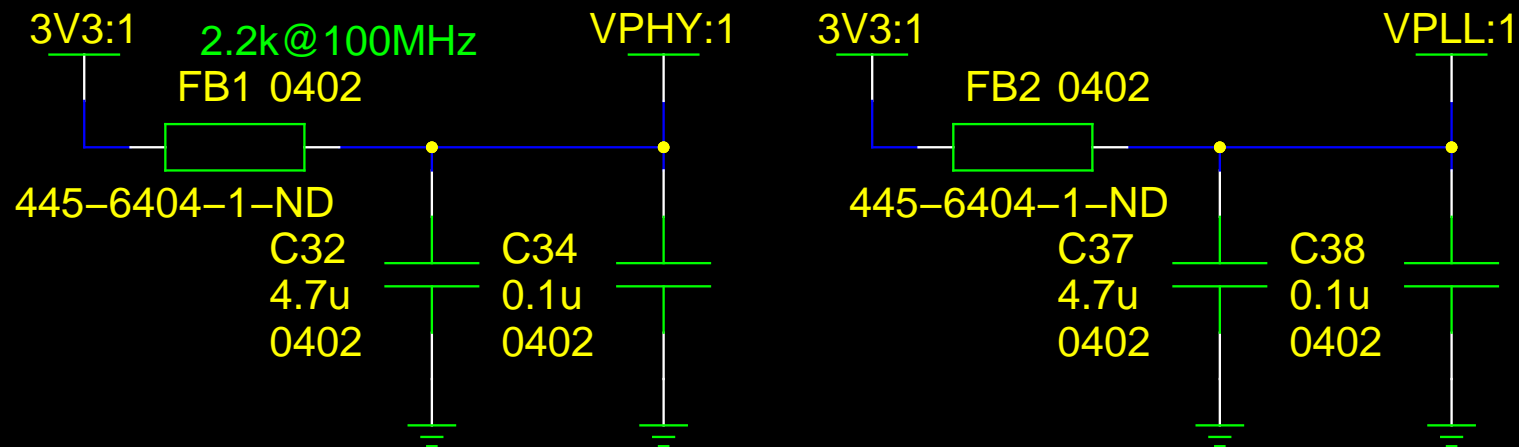
Resistor selected SCL, it should have selected SDA

Resistor selected SDA, it should have selected SCL
